Dress & Dismatic Co., Ltd. (10466)

15.MARCH.2014

ACCORD
on Fire and Building Safety in Bangladesh

Site Observations

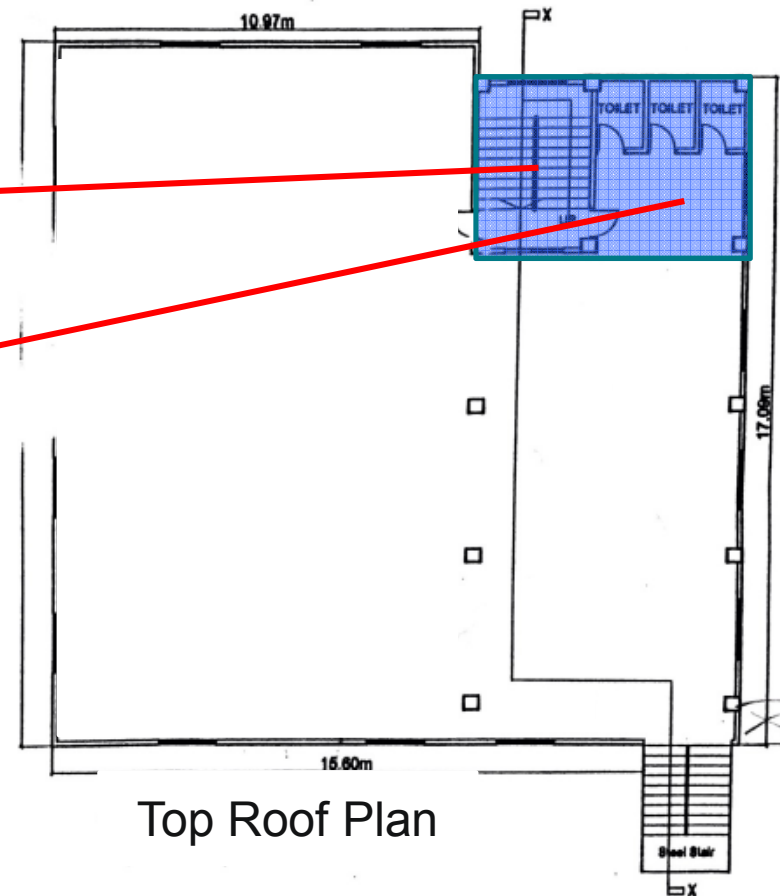
Extended concrete floor and water tank on the roof does not match submission drawing, a capacity check is required.

Extended concrete floor and water tank on the roof does not match submission drawing, foundation capacity check is required.

- Engineering assessment of factory to be carried out and in particular foundation capacity aspects to be investigated in detail.

Top Roof Plan

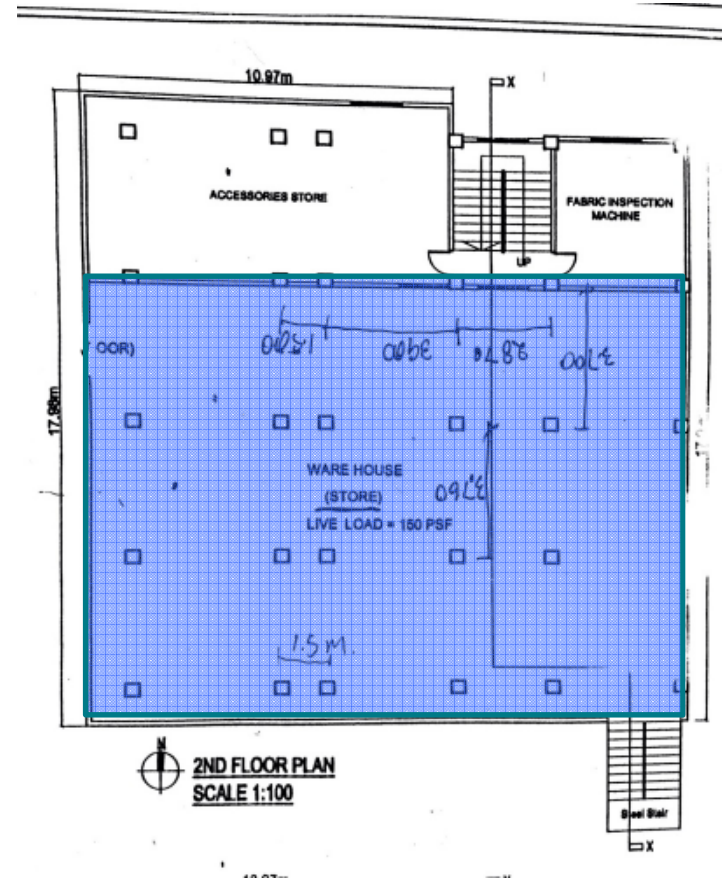
Water tank on top roof does not match with structure drawing, foundation capacity check is required.

Uncontrolled Heavy Storage Loading

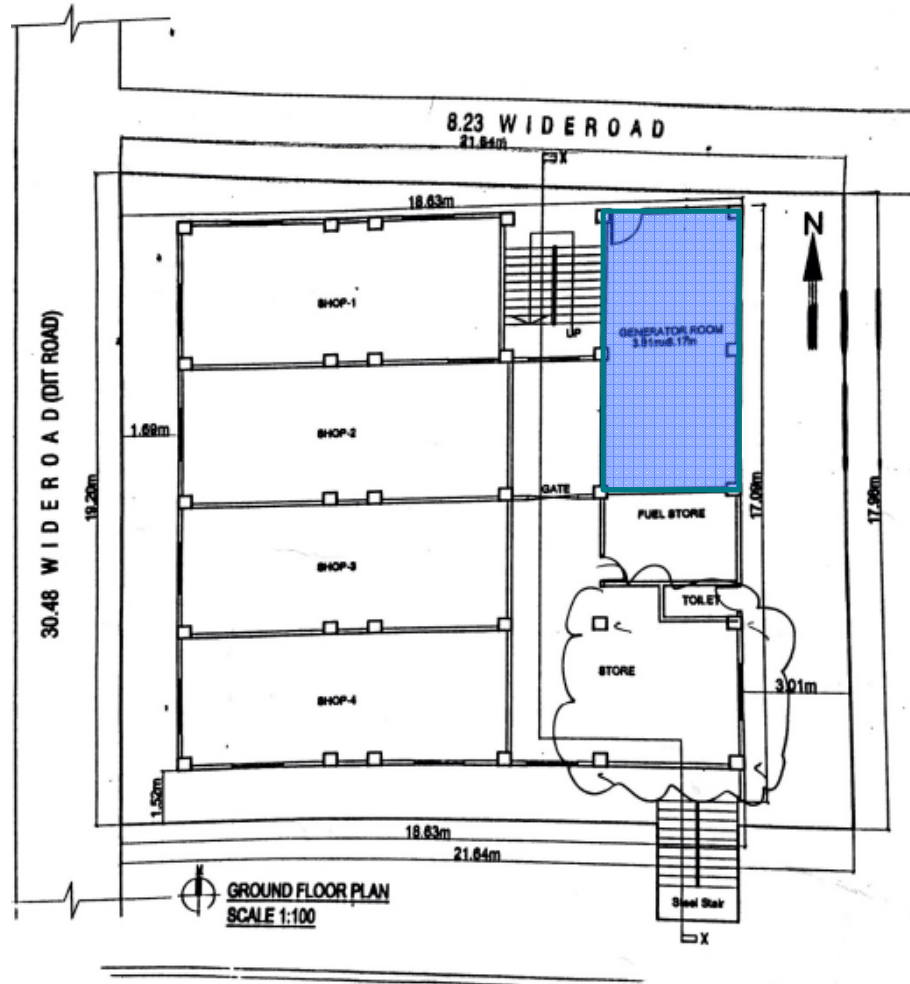
Uncontrolled heavy storage on 2nd floor. Immediately removal is required.

- Immediately reduce stacking height of fabric rolls to ensure total load does not exceed 3.0kPa

- Adopt some sort of signage/staff guidance to ensure that the maximum weight of storage is not exceeded .

- Maintain standards of quality control to ensure that storage procedures are correctly followed so that overloading problems do not arise in the future.

Slab capacity check is required

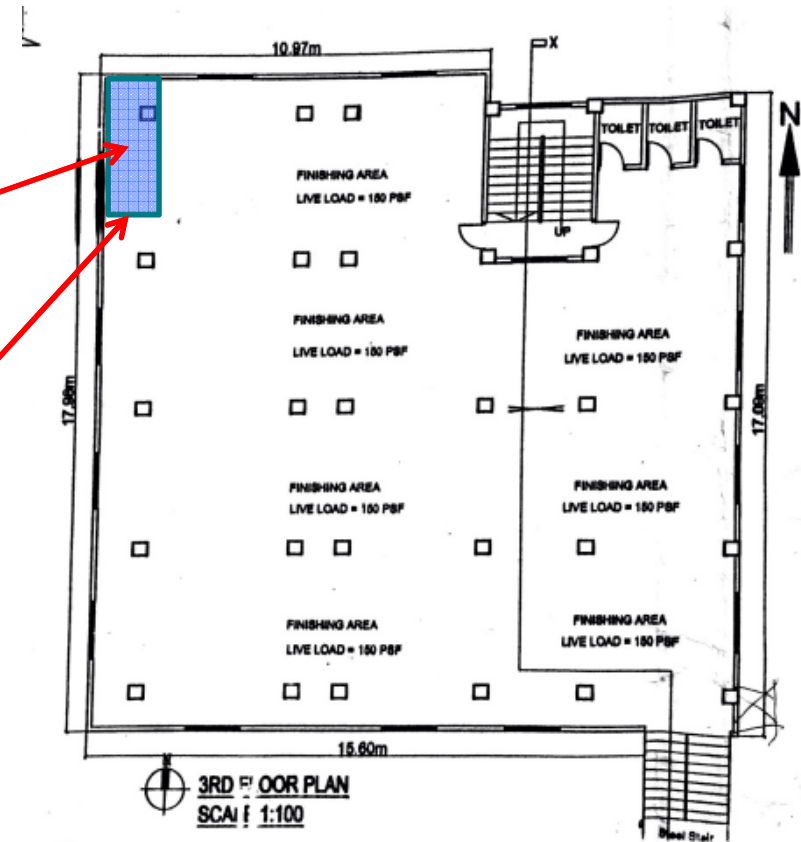
The original slab is designed for residential purpose, hence, a capacity check is required.

- Factory Engineer to review slab design and/or strengthening.

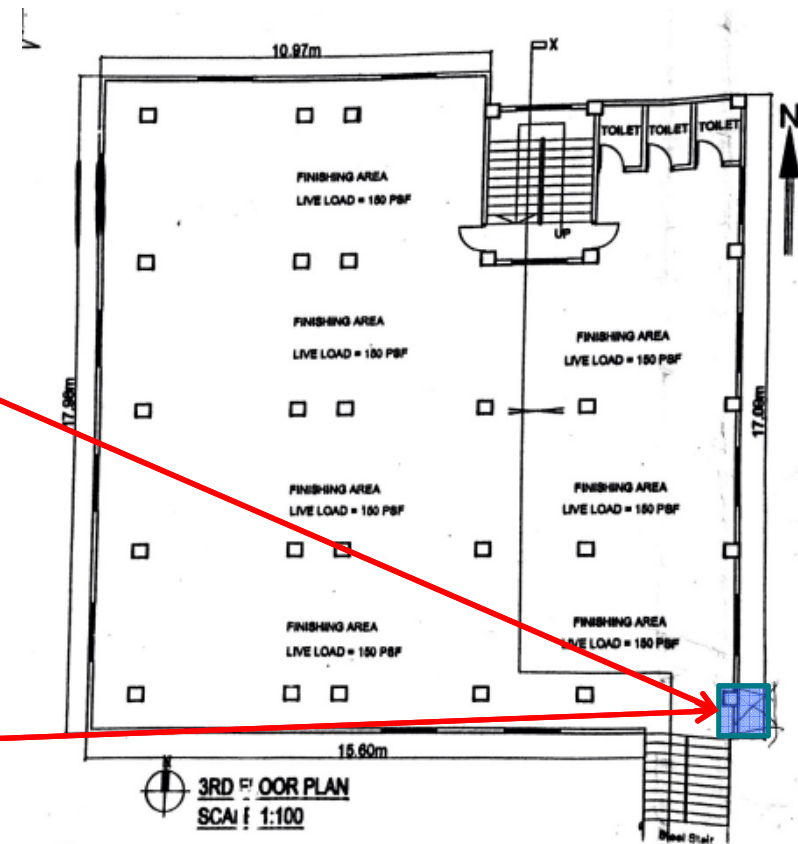
The original slab is designed for residential purposes, hence, a capacity check is required.

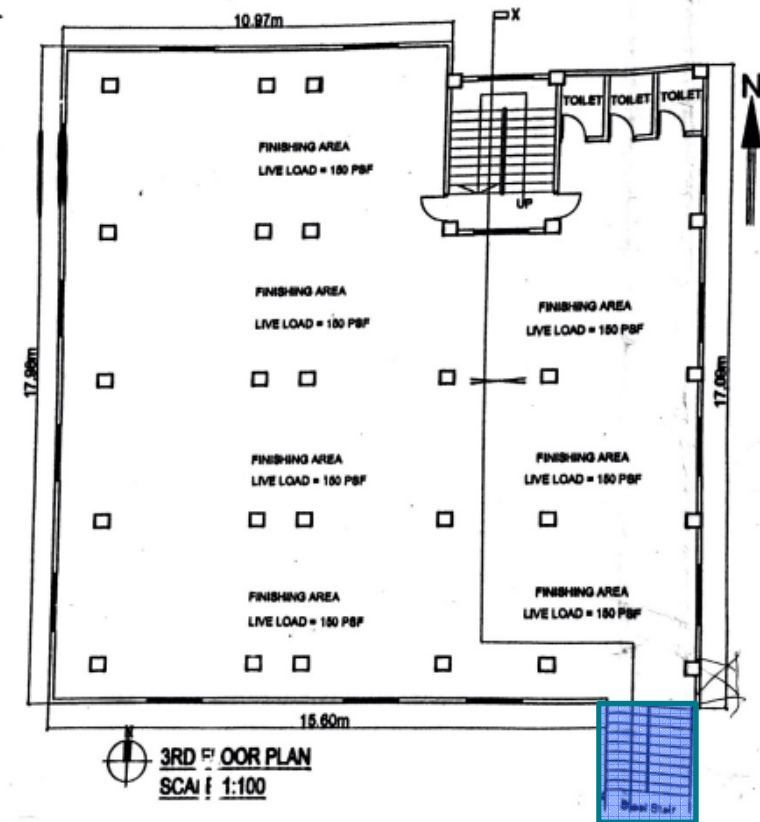
Extension cantilever slab on 2nd to roof floors does not match with structural drawings. Slab capacity checks are required.

Capacity check for steel escape stair

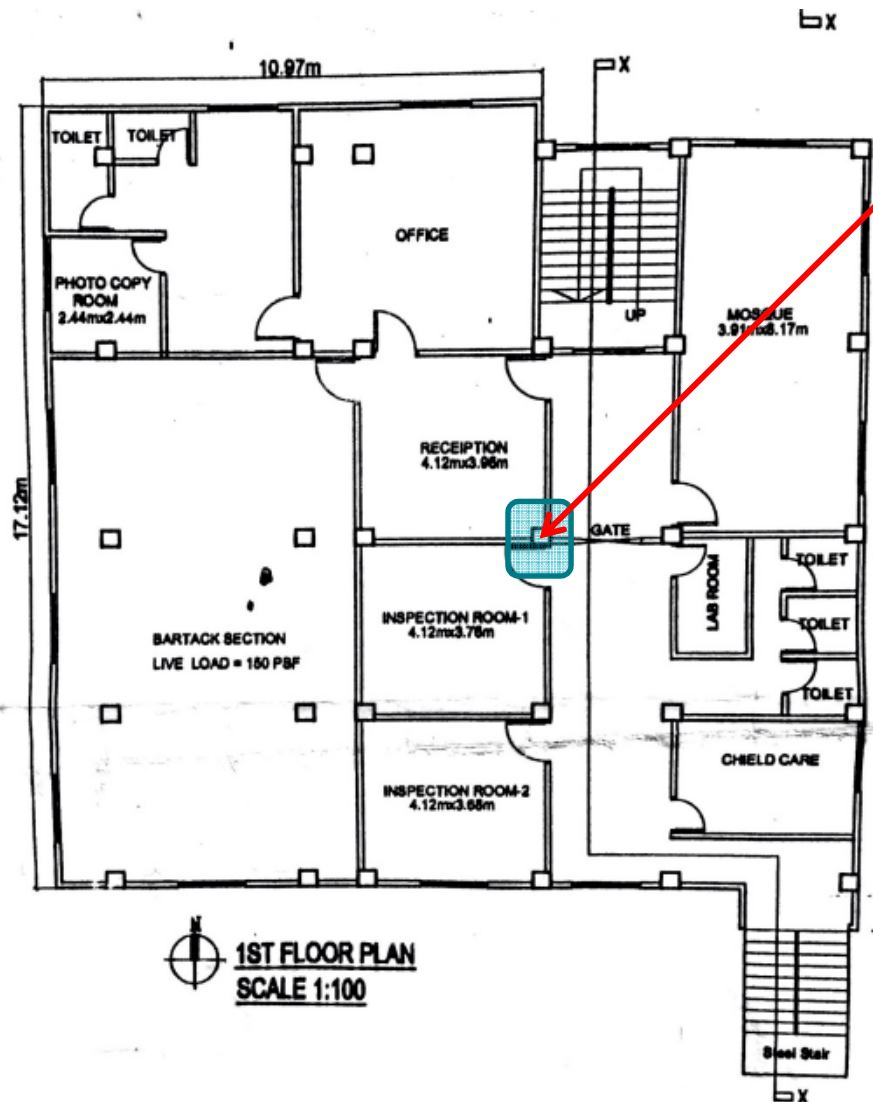
Capacity check for steel escape stair, especially at support connections.

- Detail engineering assessment to be carried out in particular the steel column capacities and the connection capacities.

- Continue to implement loading plan. Detailed Engineering Assessment is to be completed.
